Product Change Notice (PCN)

PCN Number: PCN-0450726R-01

Product(s) Affected: PJ-002AH-SMT-TR, PJ-002BH-SMT-TR

Current version	New version
Outlook	 <p>housing</p>	 <p>housing</p>
	 <p>pin# 3</p>	 <p>pin# 3</p>

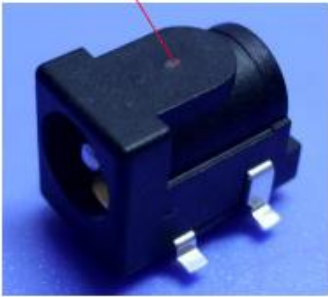
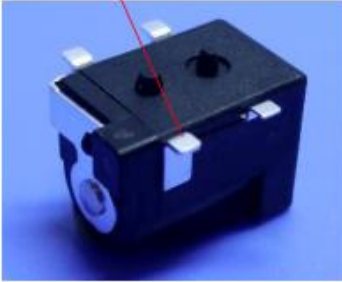
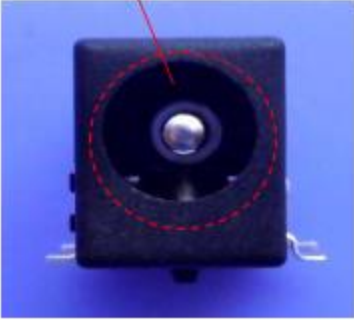
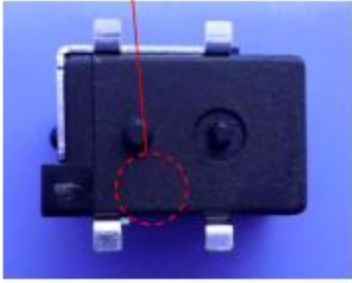
Reason(s) for Change: existing plastic housing and pin 3 molds cannot maintain efficient production.

Description of Change: to ensure quality and production efficiency, new mold development is in process. Aesthetic changes as shown below. Electrical structure and function remain unchanged.

Front	<p>jack hole without chamfer</p> 	<p>jack hole with chamfer</p> 
Bottom	<p>without cave marking</p> 	<p>cave marking location</p>
